REMARKS/ARGUMENTS

Appl. No. 10/727,752
Amndt. dated August 16, 2004
Reply to Office action of June 7, 2004

cover 10 is releasably latched in the groove along the edge region of the airbag outlet opening 9

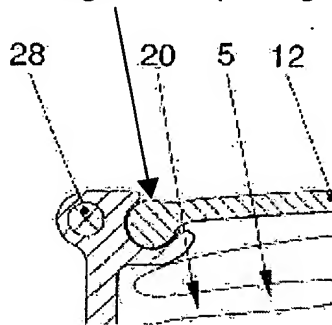
More specifically, the Examiner stated that the drawings must show the feature of a cover that is releasably latched to the edge of the outlet opening as defined in claim 20 or the feature must be deleted from the claims.

More specifically, the Examiner stated that the specification fails to describe the structure of a cover that is releasably latched to the edge of the outlet opening. The Examiner asked what kind of releasable latch is used, how the cover opens, and whether the cover is hinged.

The feature of a cover 10 that is releasably latched to the edge of the airbag outlet opening 9 is shown in Figs. 2 and 3. Figs. 2 and 3 show that the edges of the cover 10 are latched in grooves along the edge of the airbag outlet opening 9. In

Figs. 2 and 3, the edge of the cover 10 that is latched in the groove along the airbag outlet opening looks, when viewed in cross-section, like a ball and socket type connection, which is illustrated below.

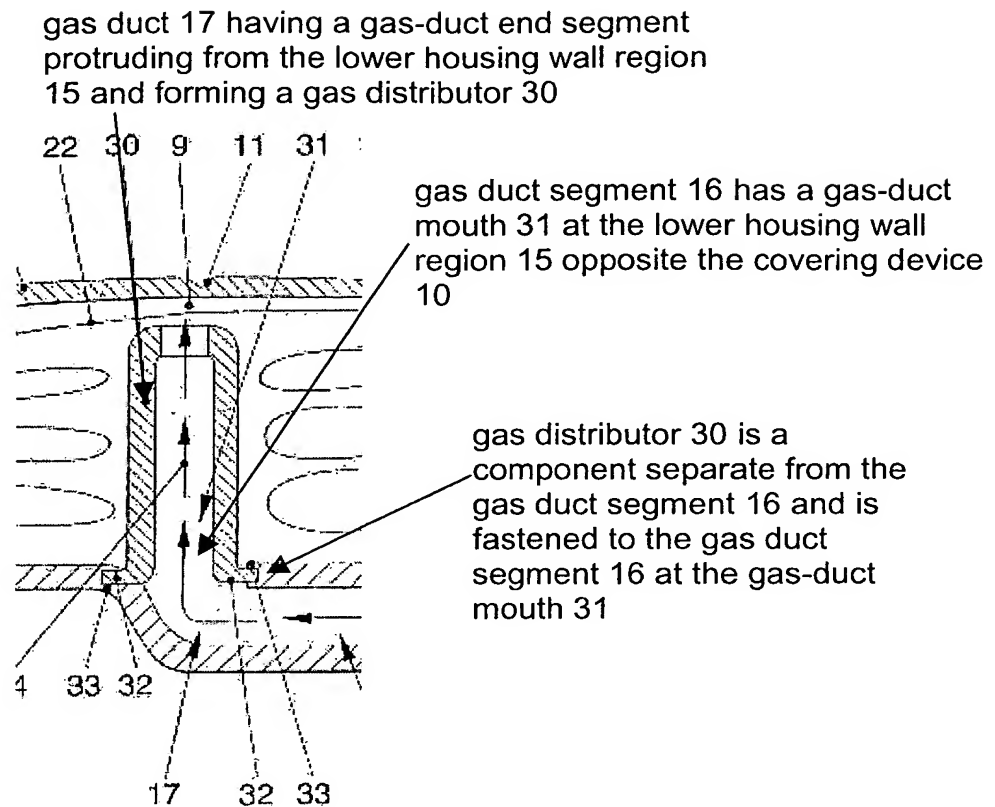
The Examiner stated that lines 34-47 of claim 1 contradict lines 39-41 of claim 1. Applicant is of the opinion that the objected to language is not contradictory and no changes are necessary. Figs. 2 and 3 show that the gas duct segment 16 extents substantially parallel to the airbag outlet opening plane and that the gas duct segment 16 is configured such that gas is guided along an airbag emergence direction. The simplified drawing below illustrates that lines 34-37 and lines 39-41 of claim 1 are not contradictory.

The Examiner objected to "said gas-duct segment" in claim 7, line 4 as being indefinite because more than one such segment has been introduced. No correction is believed to be necessary because the claim language is consistent. The gas duct segment 16 in claim 7, line 4 refers to the gas duct segment 16 in claim 1. The "gas duct end segment" of the gas duct 17 that forms the gas distributor 18; 30 is different from the "gas duct segment" 16.

The Examiner further objected to "is a separate component" and "fastened at" in claim 7 as being indefinite. Claim 7 has been amended in order to clarify that the gas distributor 30 and the gas duct segment 16 are components that are formed separate from one another and are fastened to one another at the gas duct mouth 31. Fig. 3 illustrates what is defined in claim 7. A portion of Fig. 3 is shown below.
